Certificate of Appropriateness

955 N. 31st Street

Concordia Historic District

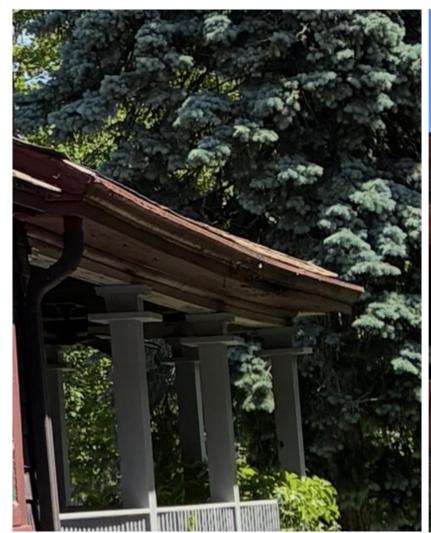
Chimney to be removed.

Left: Gutters to be replaced Right: Gutters to be matched

New gutters are only to be applied to the north side of the northeast porch.
